Service Note		
Product	Description:	Service note no.
G-System	Hum sound when connected to lower jacks	740 10 T003

Fig.1

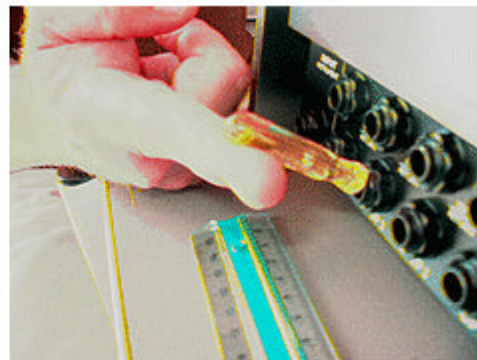
We have found out that all the double-jack connectors have a chassis connection that shorts AGND, DGND and CGND when a jack is inserted into the lower receptacle of the double-jack connector you hear a load hum sound.

The easiest way to disable the spring contact is to use a small tool, for example a small screw driver, to bend the spring in the jack connector, please be careful not damaging the connector. This modification has to be done on J9, J7, J26, J6, J5, J4, J3, J2. See fig.1

Use the screwdriver to bend the spring

Inputs that need to be modified!

Fig.2

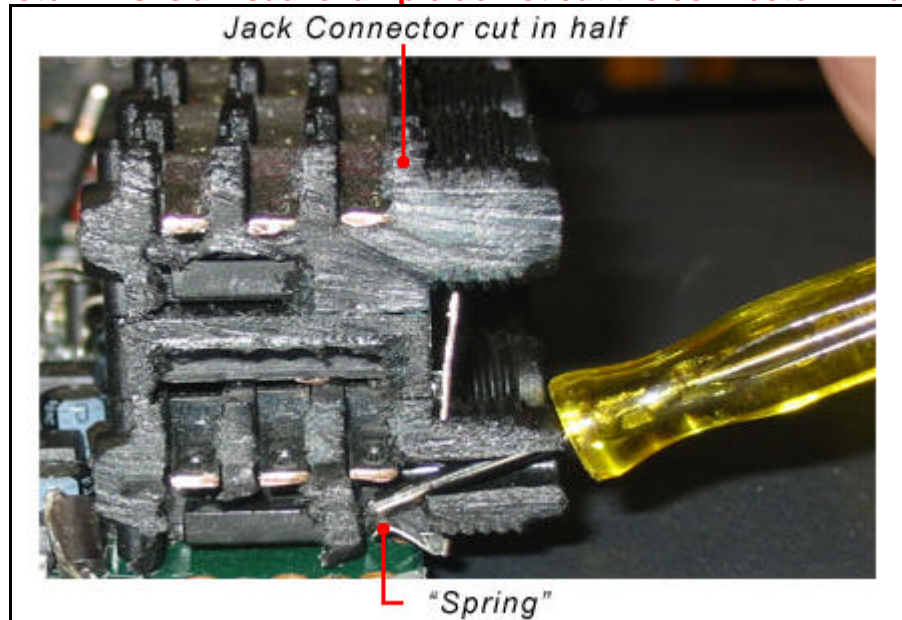
This “spring”-contact has to be disabled on all Double-jack connectors. It shorts cgnd, dgnd and agnd when a connector is inserted see fig.2

Double check that the connection is disabled. We recommend you use good lighting it's difficult to see that the spring has been bended enough.
